ADDENDUM #5

Project	Pope Francis Elementary School	Project #	pf1701
Location	387 Balsam Street North Timmins, Ontario	Date	June 21, 2017
		Pages	1 of 5

Pope Francis Elementary School Addition & Renovation
387 Balsam Street North
Timmins, ON

M&E Addendum No. 2

1 SECTION DETAIL - STAIR 122 - HANDRAIL DETAIL
 ADD-9 1:50

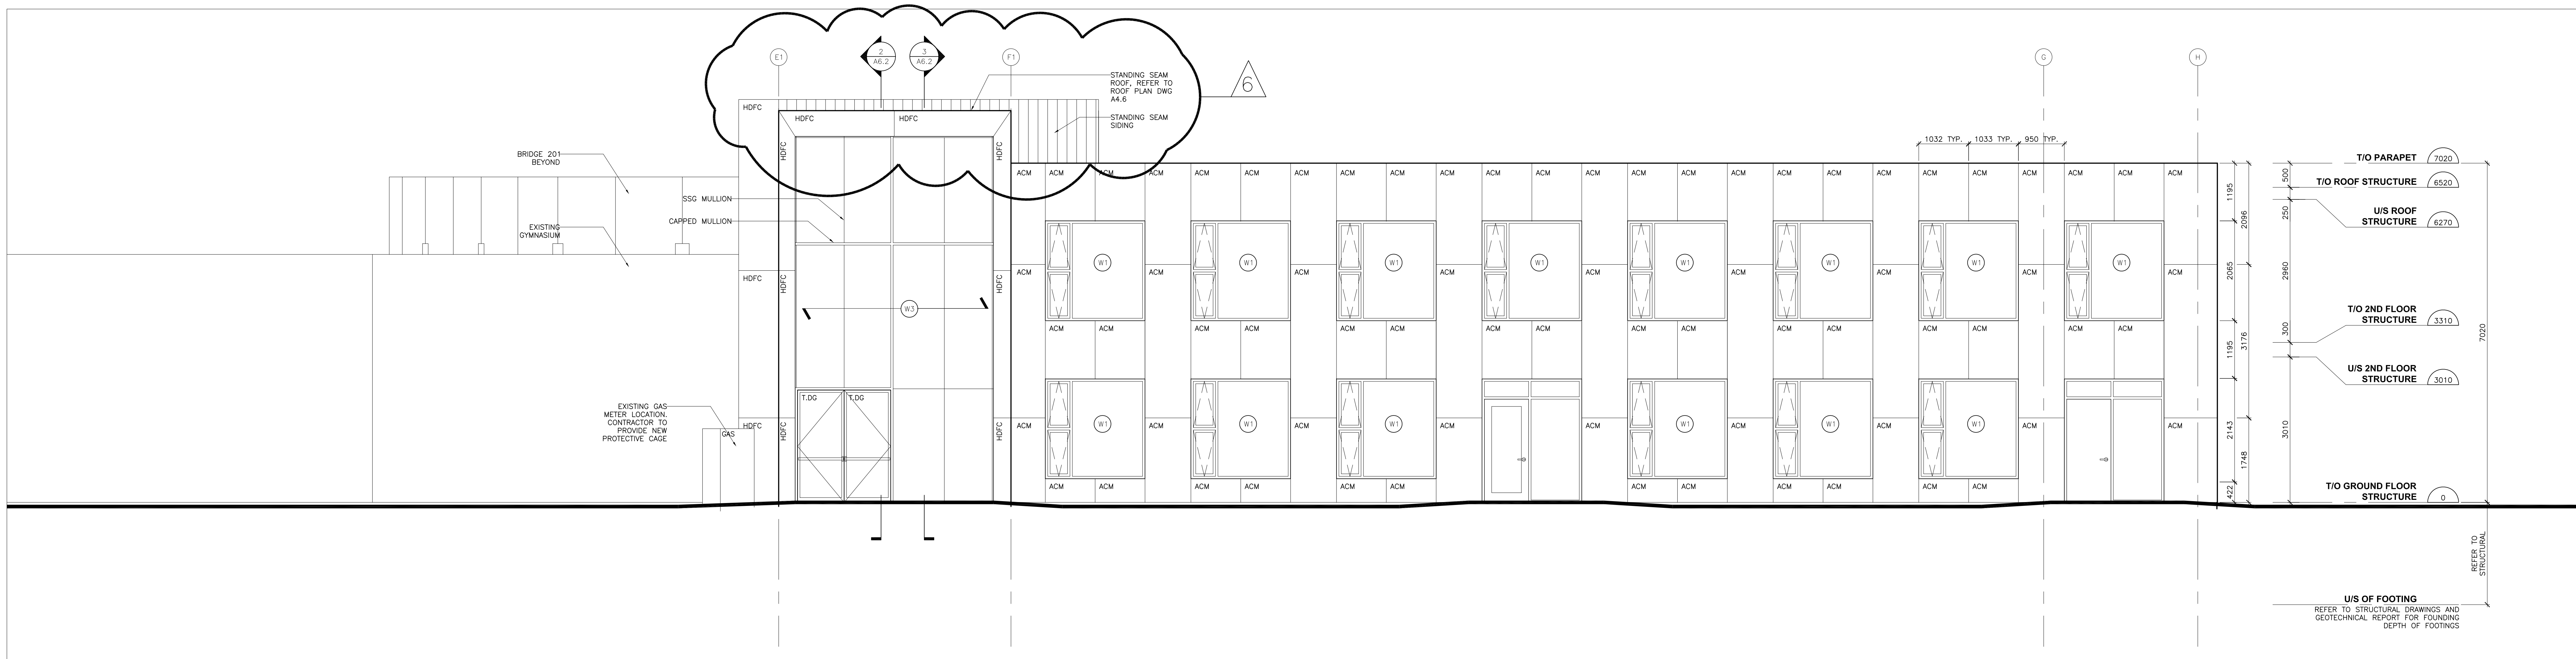
<p>of connection to portables prior to demolition”</p> <p>17. Sheet A10.1 – Interior details</p> <p>17.1. Drawing 2/A10.1 – Section Detail – Stair 122</p> <p>17.1.1. Replace drawing 2/A10.1 with ADD-9 attached.</p> <p>17.1.2. Contractor to note Steel Stair hand rail and guards.</p> <p>18. Replace Drawing A7.1 – Elevations with the Attached revised A7.1 issued for Addenda #5.</p>
Structural Addendum	<p>Refer to Structural Addendum – S05, attached.</p> <p>1. Revise Structural Addendum – S01:</p> <p>1.1. Add Helical Piers Structural Specification Pages 5 and 6 attached.</p>
Mechanical & Electrical Addendum	<p>Refer to Mechanical & Electrical Addendum #2, attached.</p>

Drawing No.: **SK-1**

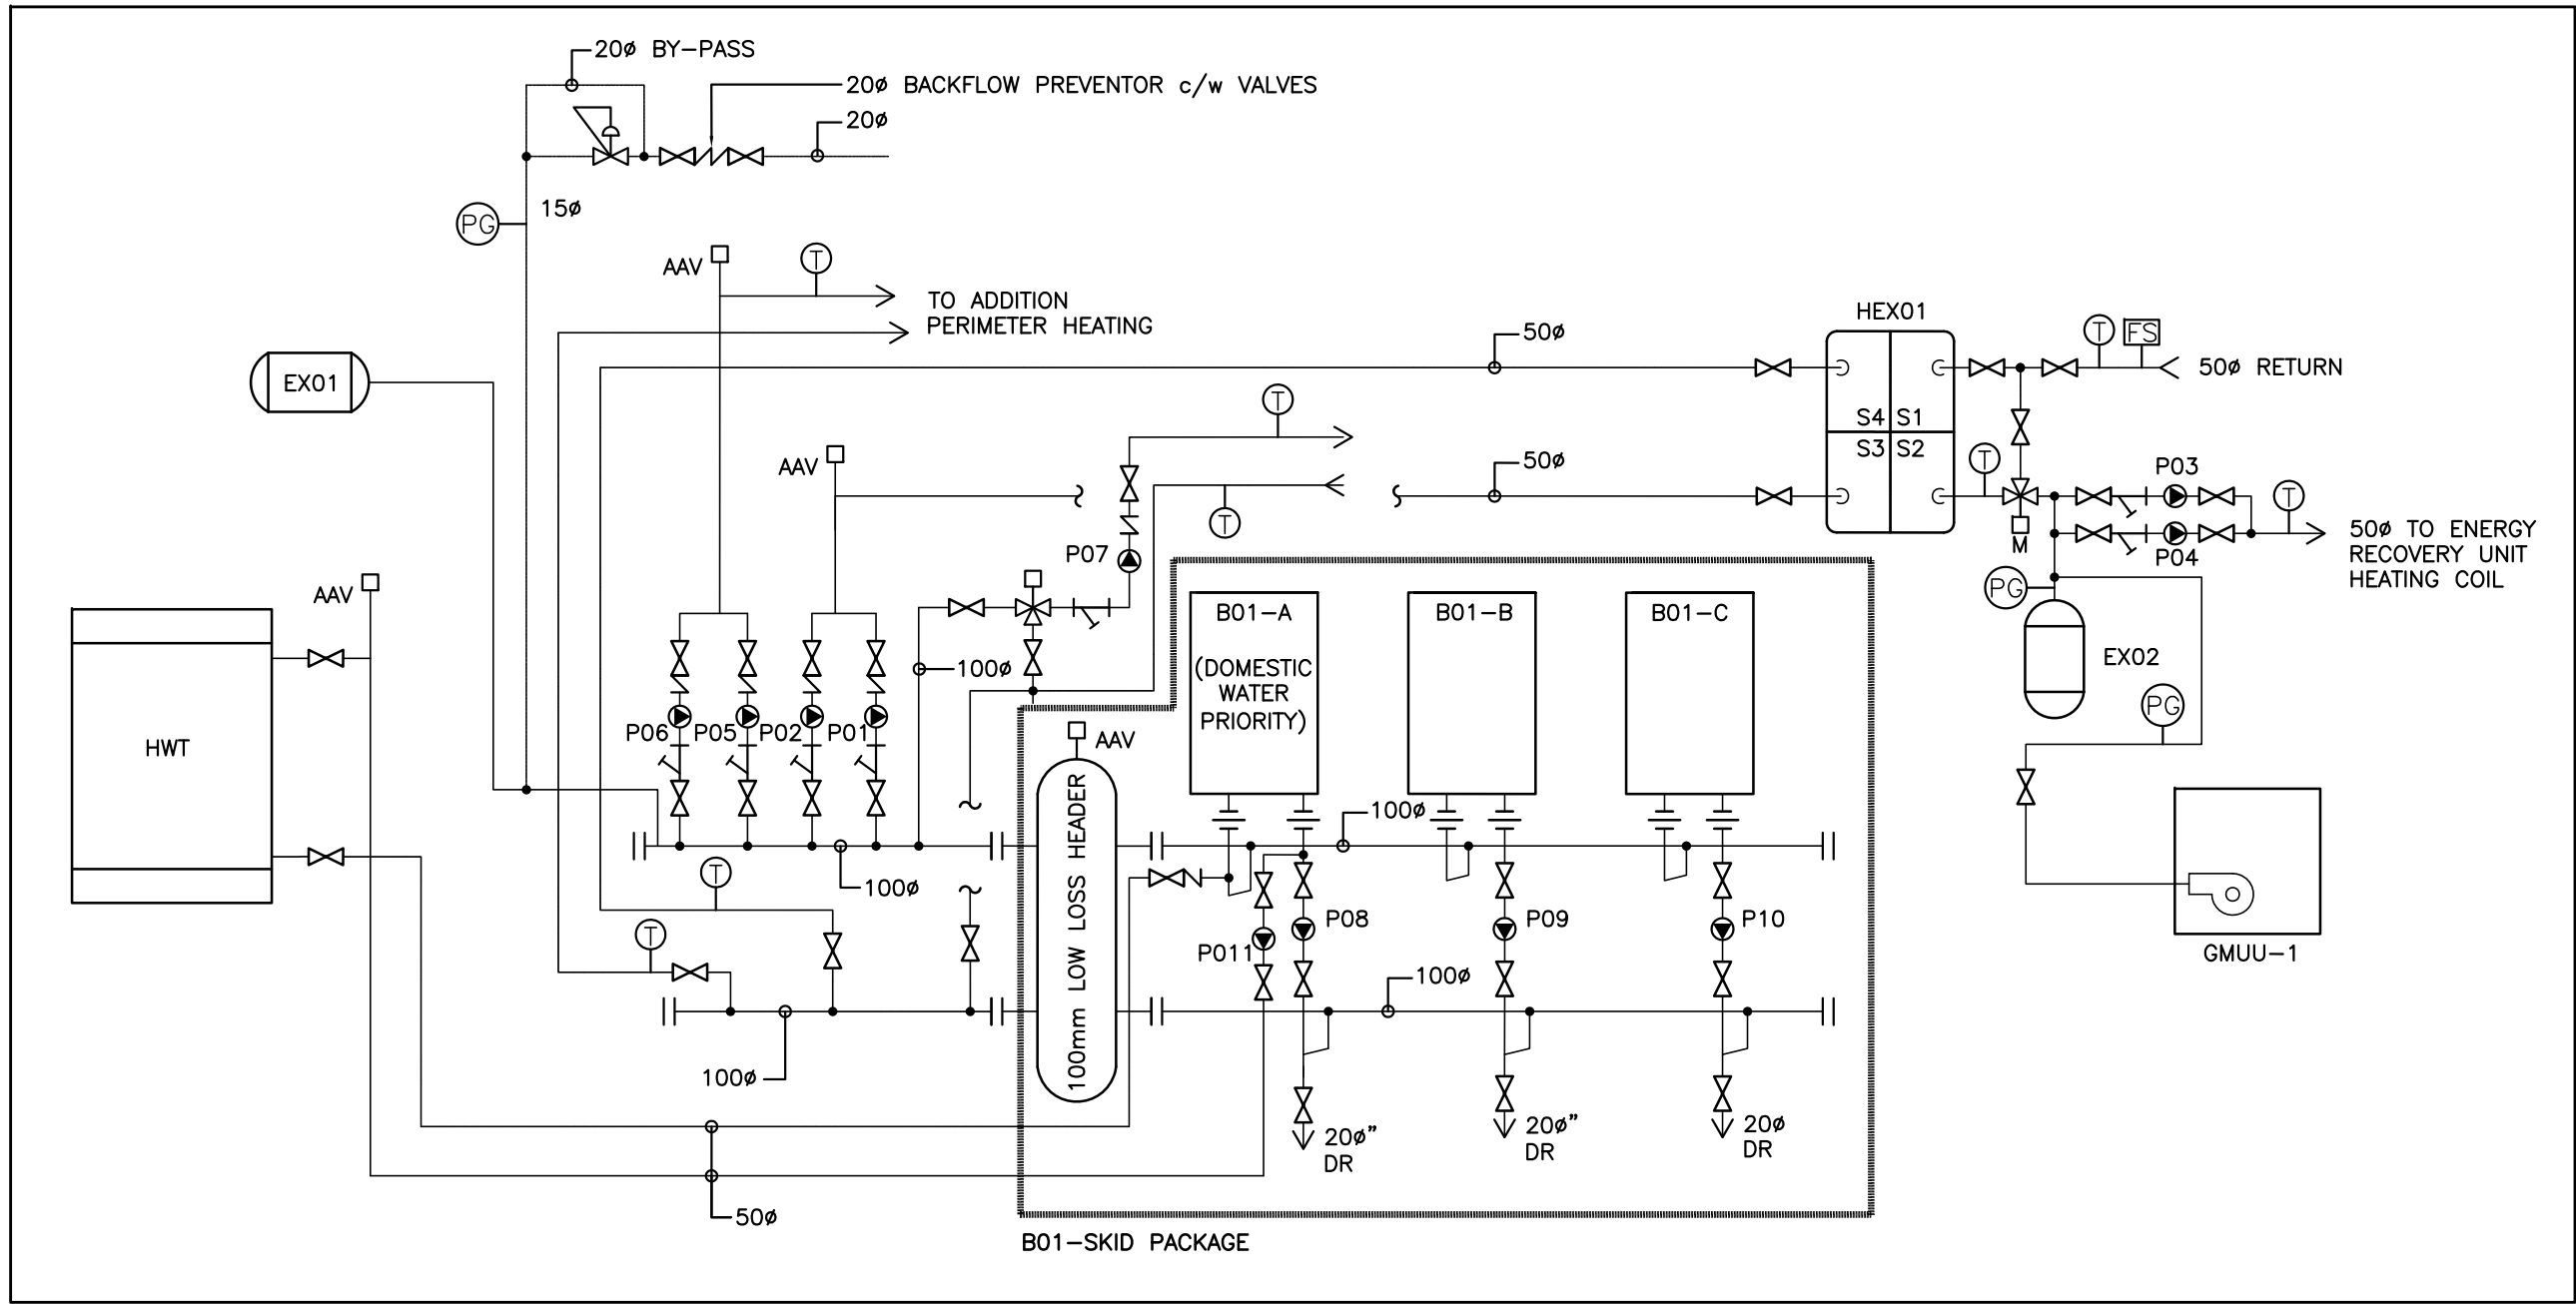
- 2.1. Electrical panel P-3 is to be changed to a 400 amp bottom entry service entrance switchboard with 400 amp main 100% rated, continuous duty breaker with interchangeable trip unit set at 350 Amps. Provide metering compartment suitable Hydro One metering CT's. All breakers to be power panel type breakers. Provide 1" continuous PVC conduit with pull cord from metering compartment to outside wall near Vestibule 125. Coordinate location with owner and Hydro One. Refer to attached sketch SK-1.

SITE PLAN
 MECH./ELEC.
 ME-1.1

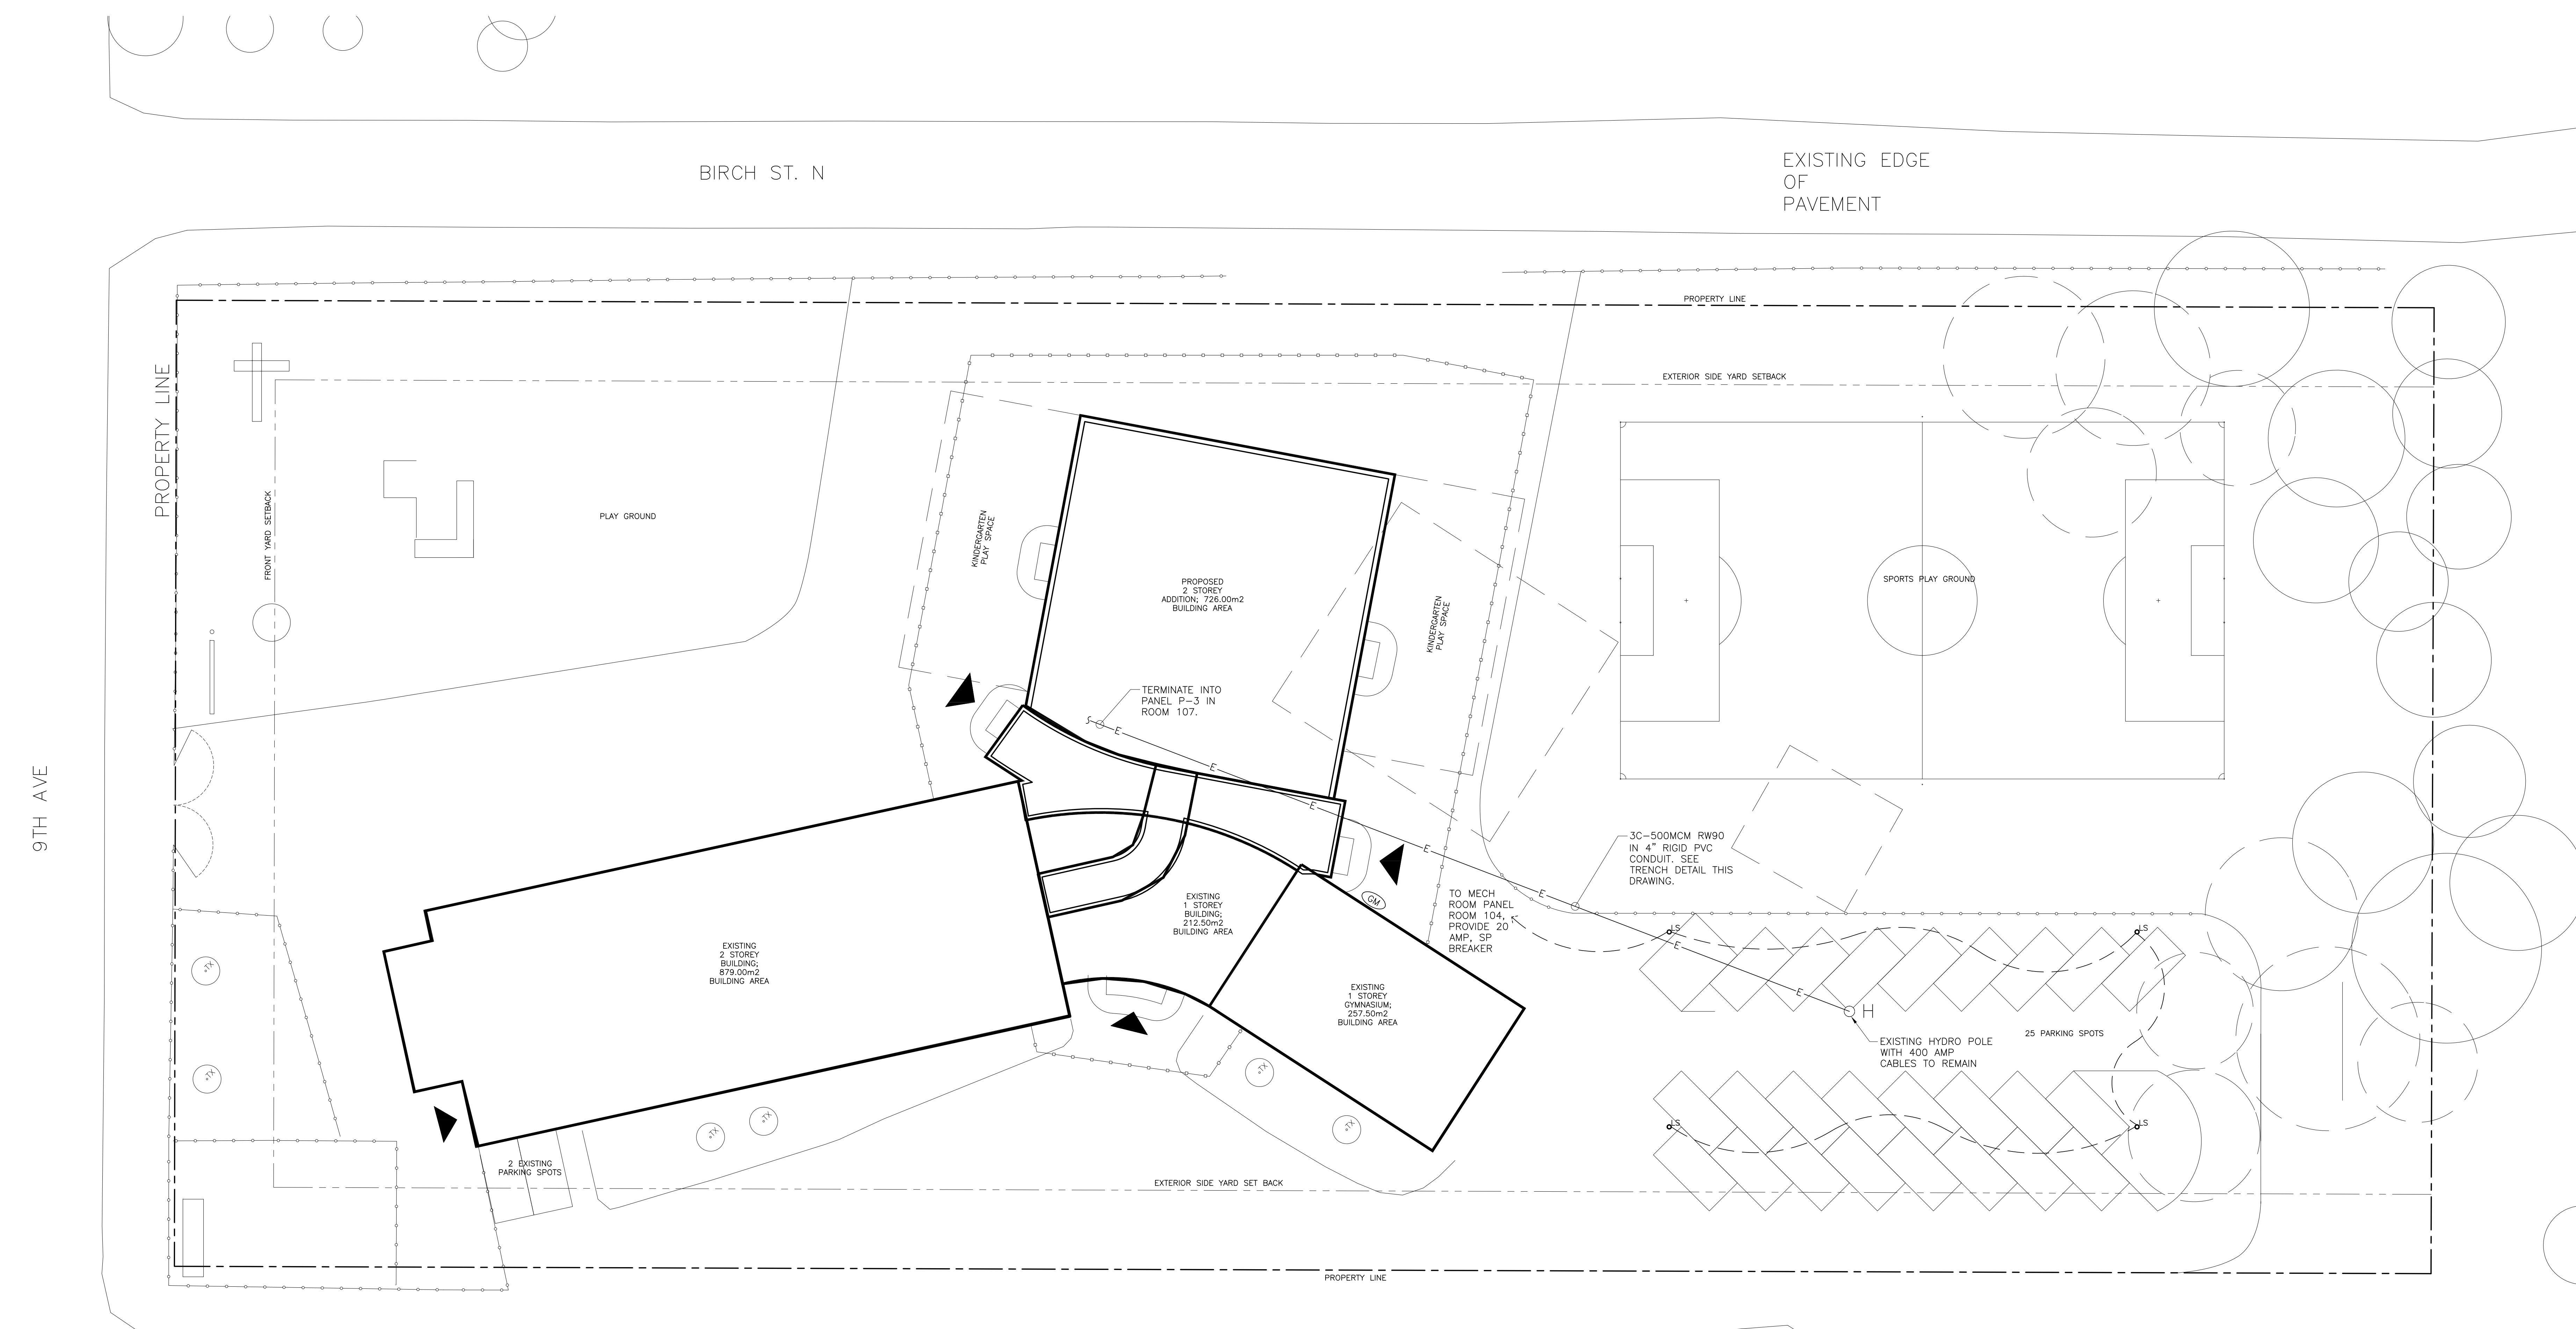
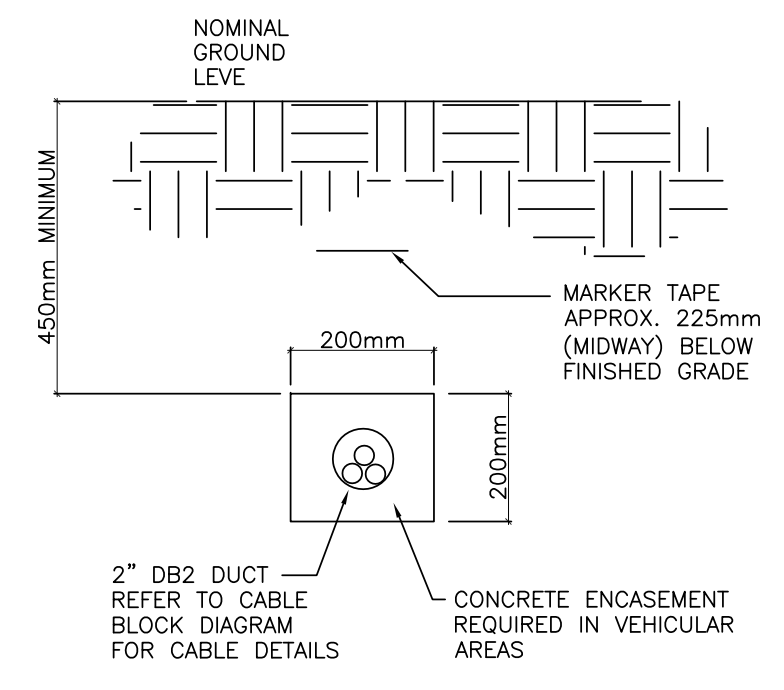
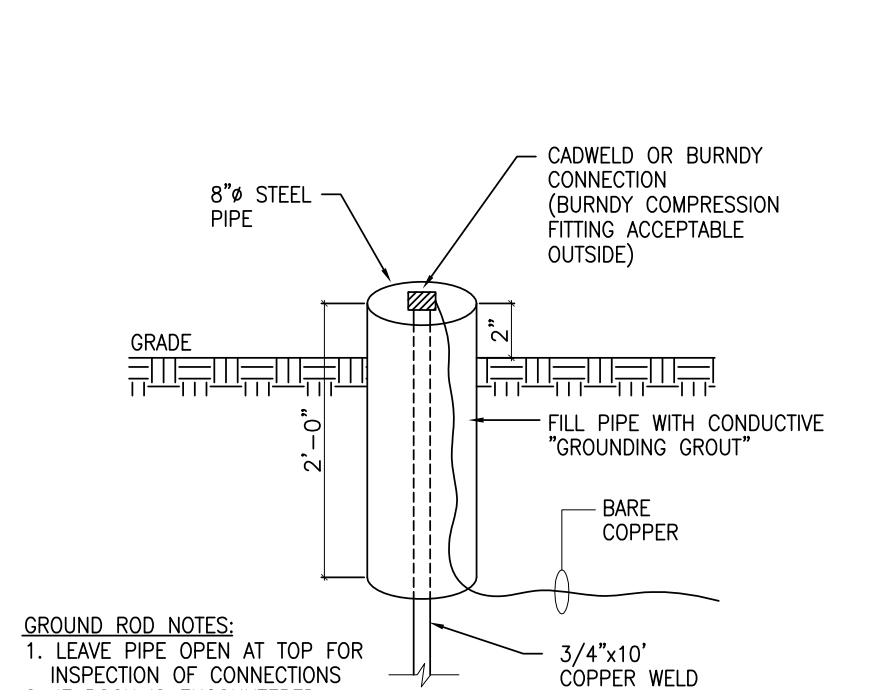
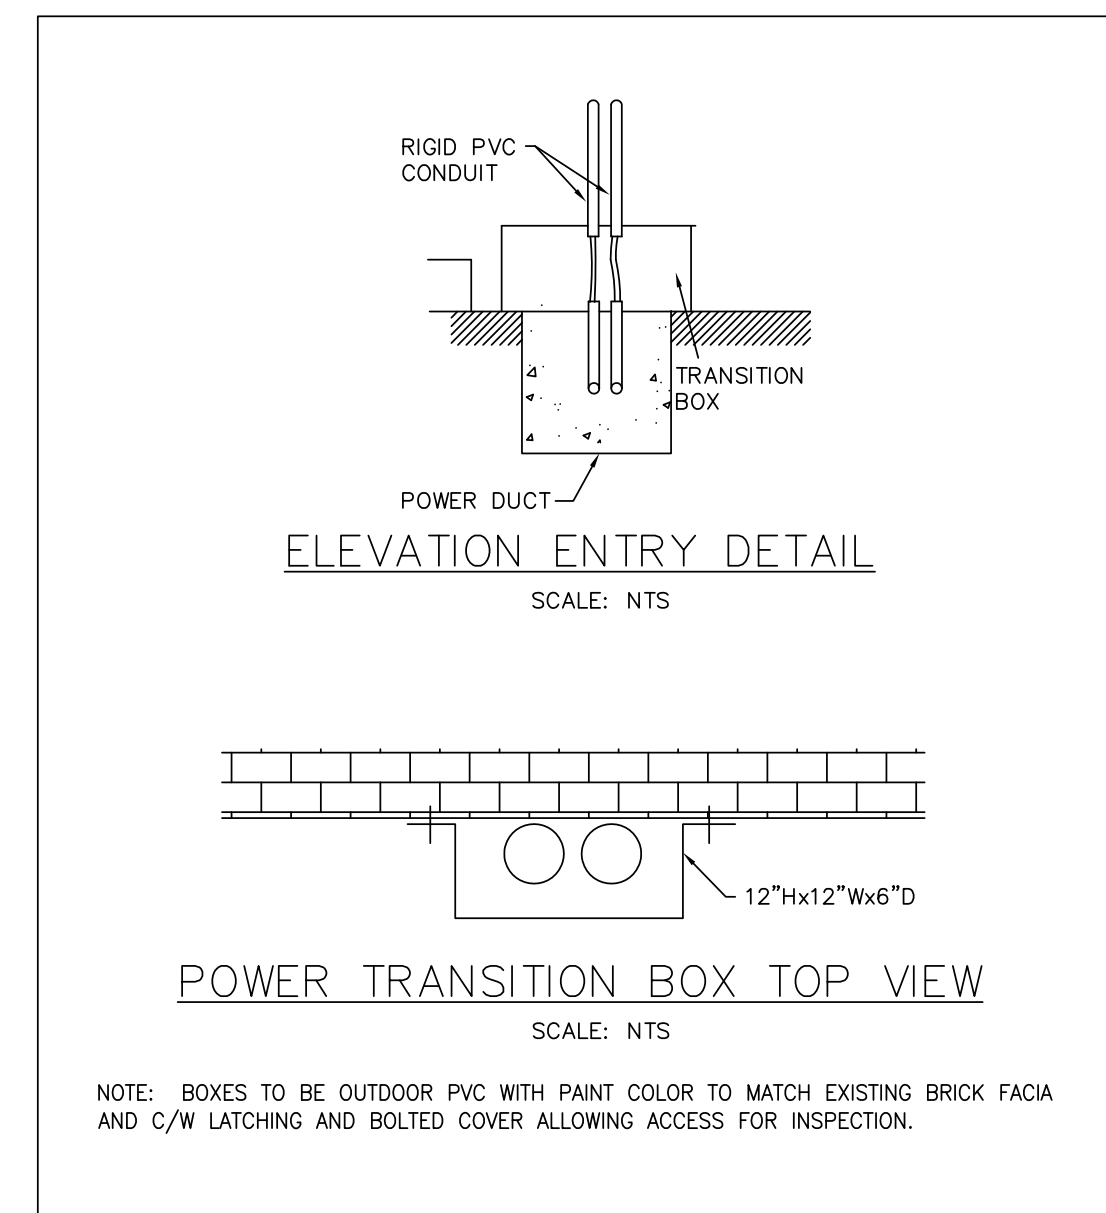
- 14.1. Refer to attached revised drawing ME1.1 Rev. 4 for the rerouting of existing 120/240, 400 Amp service presently serving the portables. This drawing shall replace drawing ME1.1 Rev. 3 issued in the Tender Documents. New underground cables are to be installed from the existing hydro pole to panel P-3 in room 107. Also see Addendum Item 2 above regarding panel P-3. Coordinate providing of new service with Hydro One.
